OPERATIONS PERMIT

Name: (owner) Raynor Builders New Installation Septic Tank
 Property Location: SR# 401 Repairs Nitrification Line
 Subdivision Sherman Lakes Lot # 12
 TAX ID# _____ Quadrant # _____
 Contractor: Mike Ray Registration # _____

PERMIT NO. 12114

IMPROVEMENT PERMIT

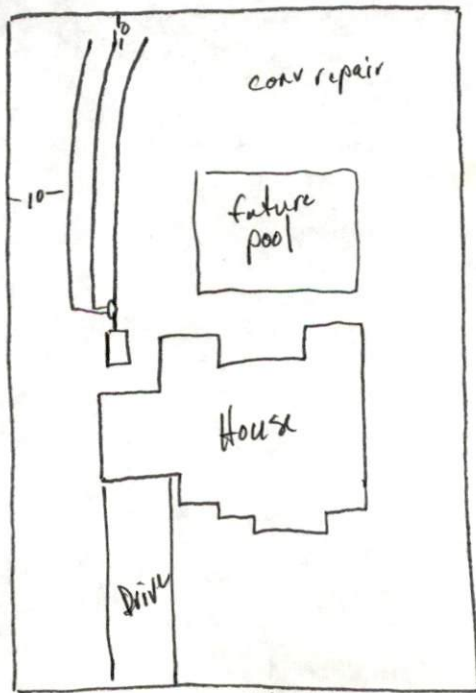
Owner requested extra line 1x150 permitted 2x150

System installed deeper than permitted but soils checked OK at deepest part

0-30LS
30-64SCL
2-64"

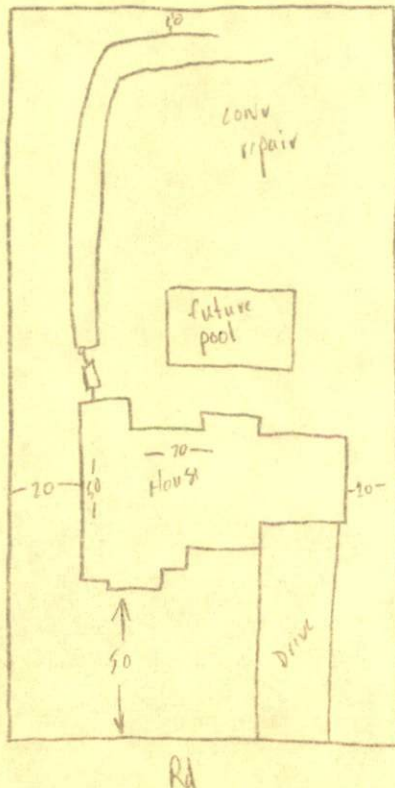
Maintain setbacks
 Contractor to meet on site
 prior to installing
 Set tank shallow
